**Rezoning Application:** PD 25-0587  
**Zoning Hearing Master Date:** July 21, 2025  
**BOCC CPA Public Hearing Date:** September 9, 2025

Development Services Department

## 1.0 APPLICATION SUMMARY

This is a request to rezone a site from Planned Development (PD) 14-0314 and PD 90-0052 (as most recently modified by MM 09-0371) to a new Planned Development (PD) in order to add a parcel for a parking garage, revise the permitted uses, and increase the max floor area ratio from 0.56 to 0.63.

## 8.0 PROPOSED SITE PLAN (FULL)

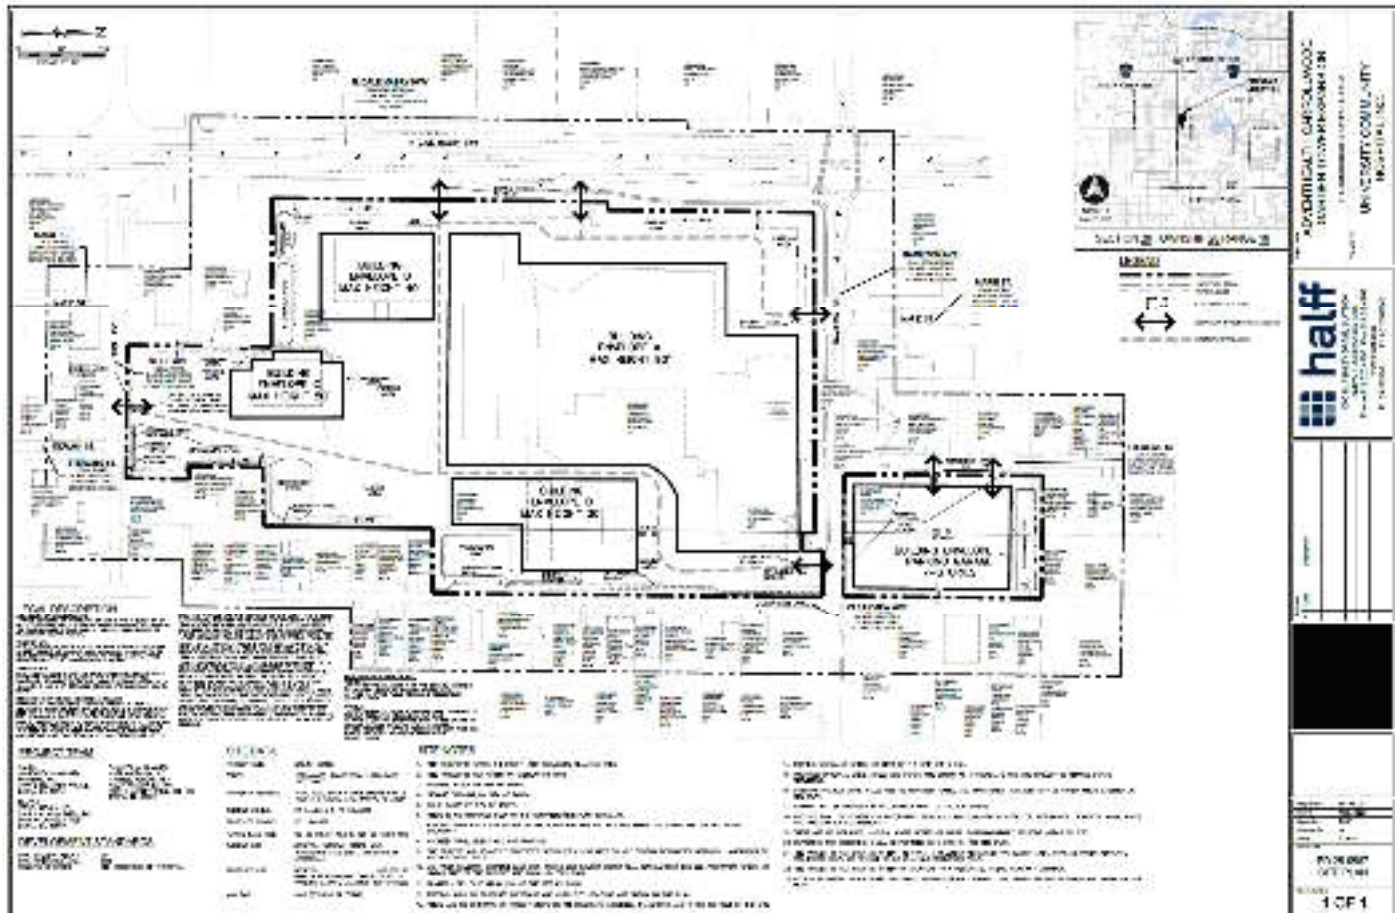
- 1. Depict buffer and screening along the eastern boundary adjacent to residential zoning on the Building Envelope E parcel.
- 2. Add graphic to site plan depicting an example of architectural standards for the parking garage.

- e. Building Envelope Area E shall maintain a 20-foot setback from the south and west property lines, a 16-foot setback from the east property line, and a 60-foot setback from the north property line with a 20-foot landscape buffer with a Type B screening. Required screening shall consist of the following:

- iii. A 16-foot-wide buffer with enhanced screening and 100% opacity, shall be provided along the northeasterly portion of the eastern property line adjacent to residential zoning.

- e. Building envelope E – maximum building height 7-stories, 83 feet. The parking garage façade shall feature architectural elements, generally consistent with the graphic provided on the certified site plan.
